# Lech Property

Old Lyme, Connecticut

REPORT

LECH PROPERTY SUBDIVISION  
 HATCHETT HILL ROAD (NORTH & SOUTH)  
 OLD LYME, CONNECTICUT

WATERSHED BOUNDARY

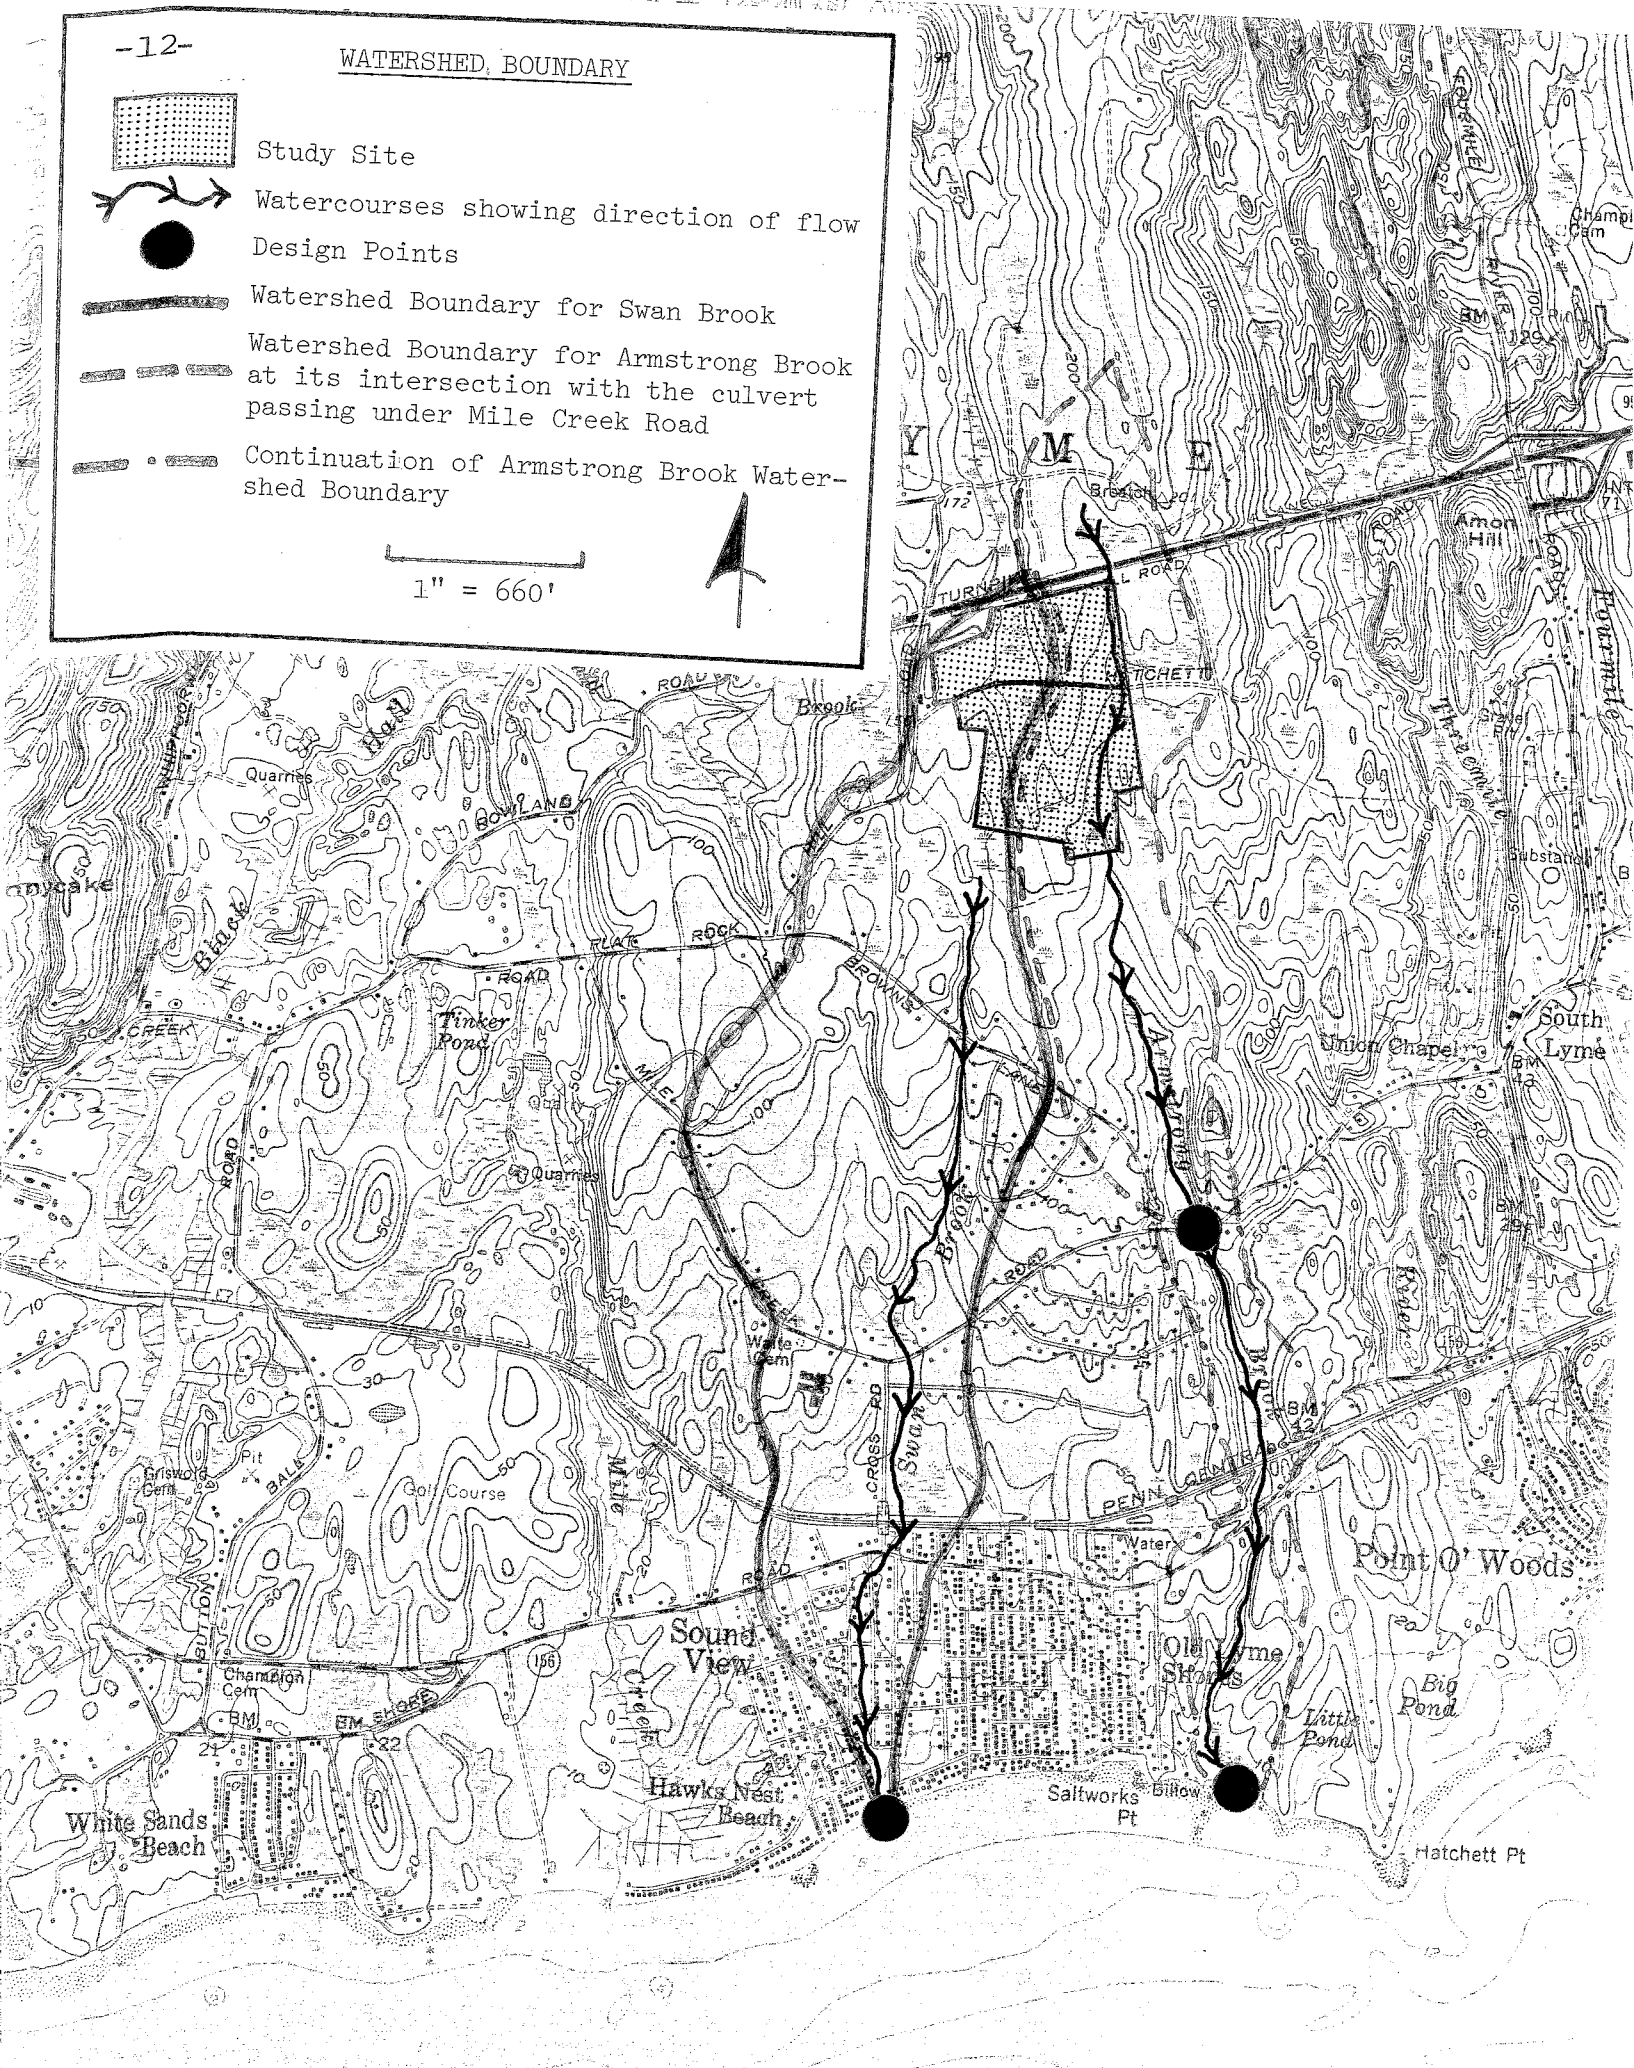
The western half of the parcels lies within the Swan Brook watershed. The wetland area in the western parts of the northern half forms the headwaters for Swan Brook. Swan Brook flows generally southward enroute to Long Island Sound. It drains a total area of about 560 acres (see watershed boundary map). This watershed is characterized by medium density residential development in the central parts, but land has been intensely developed in the southern parts. The latter consists mainly of summer homes at Sound View.

The subdivision of the property as planned, followed by the construction of new homes, driveways and cul-de-sacs would be expected to lead to some increases in runoff from the site. As mentioned earlier, increased runoff generated from the proposed subdivision would be divided into two (2) watersheds. This will help to lessen the effects of post-development runoff on any one watershed. Because the density of development is relatively low (about 15 homes plus roads) for each watershed, it is expected that any peak flow increases would be small. In addition, wetland areas on the site and downstream will serve as natural runoff control basins. Under these circumstances, it seems likely that on-site runoff detention will not be necessary. Nevertheless, as a matter of policy, the applicant's engineer should supply the Town with a stormwater management plan which includes hydrologic calculations. Close examination of downstream culverts, especially at Brown's Lane, Mile Creek Road and at Sound View is warranted. If flooding problems exist at any points downstream, even a minor increase in runoff from a potential development could further aggravate an existing situation.
